6C Containment Debris Protection for ECCS Strainers

The information in this appendix of the reference ABWR DCD is subject to several changes due to the adoption of a complex ECCS strainer design (e.g. Cassette Type Strainer). Consequently, for clarity it is presented in its entirety with the following departures incorporated. This strainer design has been used at numerous BWRs in Japan and numerous PWRs in the United States. The strainer is described in this appendix. Departure STD DEP Vendor changes General Electric (GE) to Toshiba in Section 6C.1.

STD DEP 6C-1 (Figure 6C-1)

Figure 6C-1 Cassette Strainer Cutaway

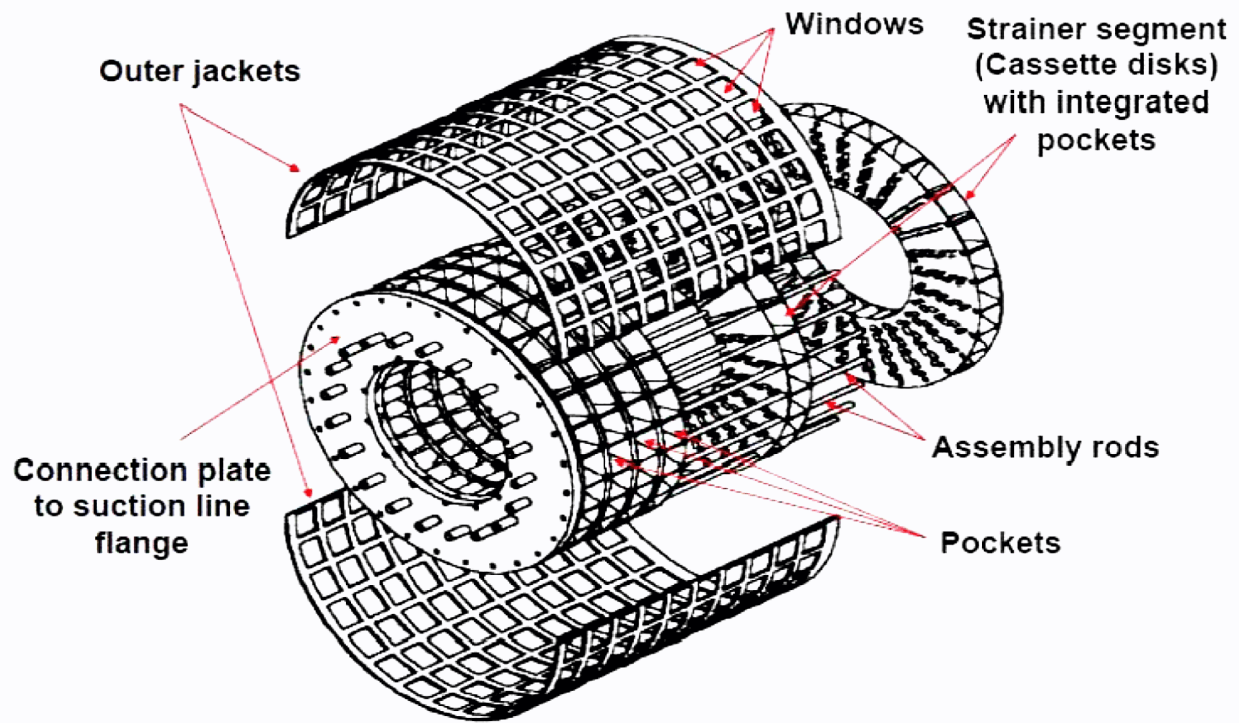
The suction strainers design at Perry preceded and did not meet the current regulatory requirements. The ABWR ECCS suction strainers will utilize ~~a "T" arrangement with conical strainers on the 2 free legs of the "T"~~ a cassette type strainer design. ~~This design separates the strainers so that it minimizes the potential for a contiguous mass to block the flow to an ECCS pump.~~ The design of the strainers will be based on Regulatory Guide 1.82, NUREG/CR-6224 (Reference 6C-4), NUREG/CR-6808 (Reference 6C-5) and the Utility Resolution Guidance, NEDO-32686-A. The cassette type strainer design is based on a set of cassette modules with U-shaped filter pockets attached to the cylindrical outer jacket. Each strainer consists of filter modules, the outer jacket and flange plates on each end of the cylindrical assembly. The filter module is constructed with cassettes which are arranged axially along the strainer axis. One cassette consists of pocket shaped filters which are arranged radially. A cut-away drawing of the strainer is shown in Figure 6C-1. The material used in the cassette type strainer is stainless steel. The cylindrical strainer assemblies are mounted in pairs on piping tees at each ECCS pump suction line. When the ECCS pump operates, the suction flow in the suppression pool runs into all pockets through the outer jacket windows. Each pocket has five flow paths from the inlet through the five perforated walls to the outlet of the pocket towards the cassette strainer. By using the cassettes with the pocket shaped filters, the strainer has an available filter area which is larger per volume than cylindrical and other shaped strainers. The number of cassettes and pockets is adjusted to produce a specific head loss performance for the strainer. To avoid debris clogging the flow restrictions downstream of the strainers, the size of the holes in the perforated sheets is chosen by considering specific flow paths of ECCS equipment and piping (for example, the containment spray nozzle and the ECCS pump seal cooling flow orifices). The strainers will have holes no larger than 2.1 mm.
